**Planning & Zoning Commission
Tuesday, October 17, 2023, 6:00 PM
Public Meeting Room / Eagle Town Hall
200 Broadway, Eagle, CO 81631**

1. Project: 263 Sawatch Road Major Development Permit
File # DR23-04
Applicant: Dave Dantas and Rick Patriacca of Sawatch 263 Rd. LLC
Location 263 Sawatch Rd
Staff Contact: Jessica Lake, Planner II
Request: Application for a Major Development Permit, with design variances, to construct three buildings, each with three commercial units and three residential units accessory to a non-residential use, as approved via Resolution 37-2020. A zoning variance is requested for this project for joint use of parking spaces, pursuant to Section 4.07.140.H. of the Municipal Code.

RE: 263 Sawatch Rd, Development Permit response to P & Z board/ town staff comments on 9-19-23,)

Section 4.07.020. – Landscape Standards

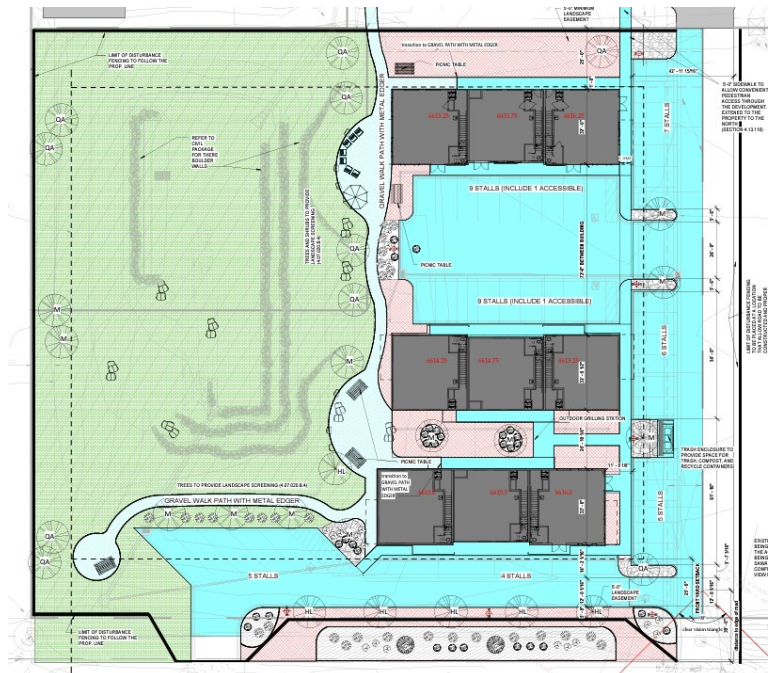
Staff Comment: An updated landscape plan has been provided and where landscaping does not fully meet the code requirements, conditions of approval are provided at the end of the staff report for the Commission’s review. A design variance request has been included below to address the landscape buffer on the east side of the property. The updated landscape plan and new recreation diagram show additional useable space between the western side of the buildings and the detention pond. This area has a mix of gravel and seeded grasses and plantings, the applicant also added additional boulder retaining walls to step that side down into the bottom of the pond. Two evergreen trees have been added to the front street buffer area within the increased planting strip. Staff recommends switching out the proposed sod in this area with the seed mixture proposed in the detention pond. The seed mixture proposed is a mix of grass and fescue seeds that is a native low growth mountain mix. Three groupings of two trees each have been added along the western edge of the property to better screen between uses on the properties. A gravel path has been added to the north of the diagonal parking spaces near the front of the property.

Original Pond Improvements Plan

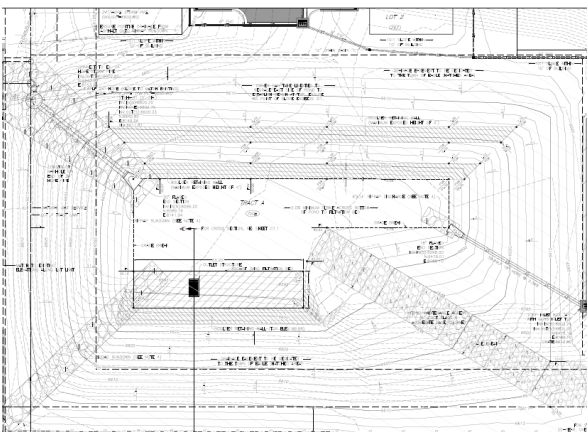
Staff Comment: An updated Pond Improvement Plan and Grading Plan have been submitted based on P&Z feedback. The overall shape of the detention pond has been modified slightly with the proposed changes, planning staff has not yet heard from Public Works whether or not the changes to the detention pond still meet the Town's requirements for this facility. The overall slope along the southern side of the detention pond has been reduced. The slope on the western and northern sides has not changed from the original plan. The proposed retaining walls have been altered in the new plan. As shown below, the original two retaining walls on the eastern side of the pond now extend and wrap around to the southern side in the updated plan. The updated plan also shows an additional two retaining walls along the eastern side to accommodate the extended useable amenity space along the buildings.

Updated Pond Improvements Plan

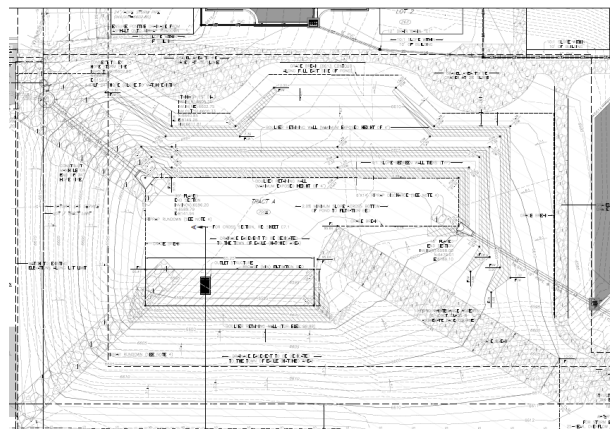
A split rail fence will surround the detention pond along the slope and will include a gate at the Town's accessway. The gate will need to be wide enough to accommodate any Town vehicles or equipment that

may need access. The exact positioning of the fence can be determined either as part of the building permit or the grading permit. Staff is also including a condition for an ownership and maintenance agreement to be created for this area to define the ongoing maintenance responsibilities of the detention pond. Staff is electing to keep condition of approval #11 to ensure that Public Works comments will be incorporated into the final grading plans and to define the process for any minor or substantive changes to the development plan as a result of grading permit or lot line review.

1 OUTDOOR RECREATION PLAN
1/16" = 1'-0"
Project North

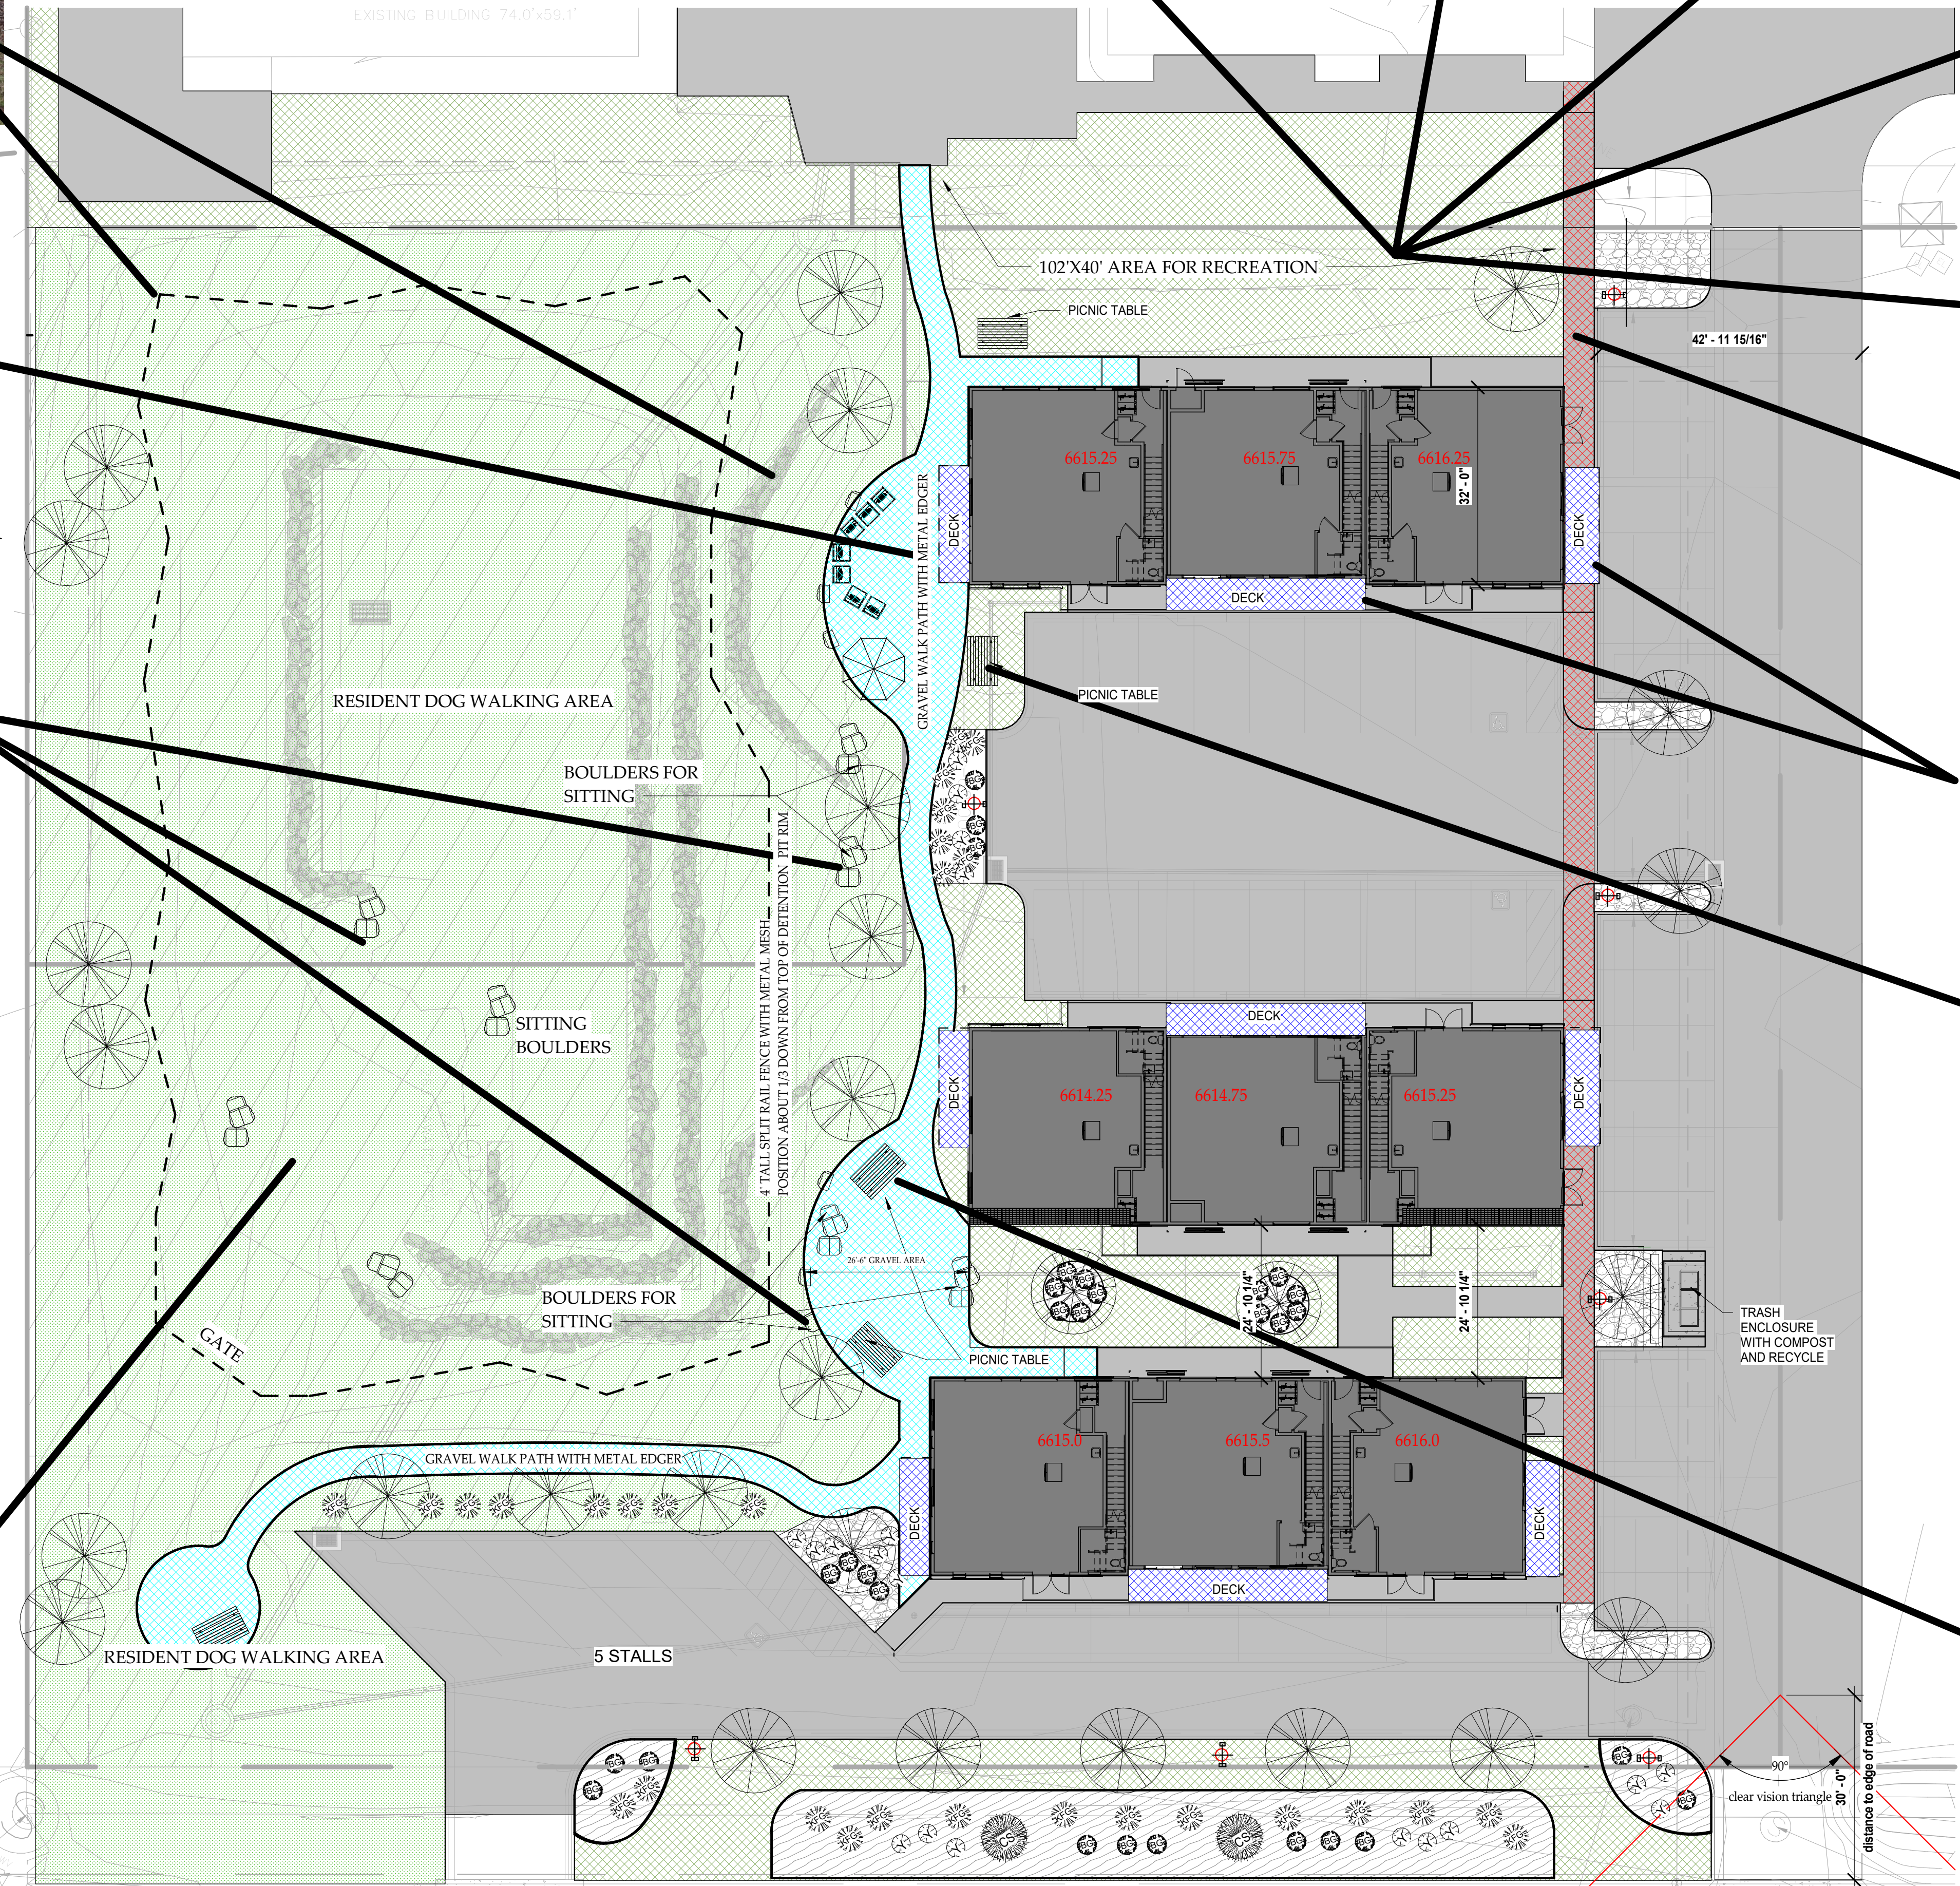
Describe Recreation opportunities on the property: Refer to new sheet A1.3, movie and 3D images

- 1 We have created flatter graded benches with retaining walls within the east and south side of the pit on the sides before the detention pit gets too steep.
- 2 Gravel walk path has been added.
- 3 Fenced the detention area with a split rail fence for safety and for a resident dog walking area. This fence will be 4'-0" tall and be positioned 1/3 down from the rim of the pit.
- 4 There are rocks to sit on like at Ford Amp.,
- 5 added gravel terrace areas with seating on the west side of the building to energize the areas that will have good afternoon sun and be adjacent to the open area of the detention area.
- 6 Identified on the sheet is a 40'X102' green space between Building 'C' of 700 chambers and the north building of 263 Sawatch development as a place for recreation.
- 7 Each apartment has a private deck for outside living/enjoyment.
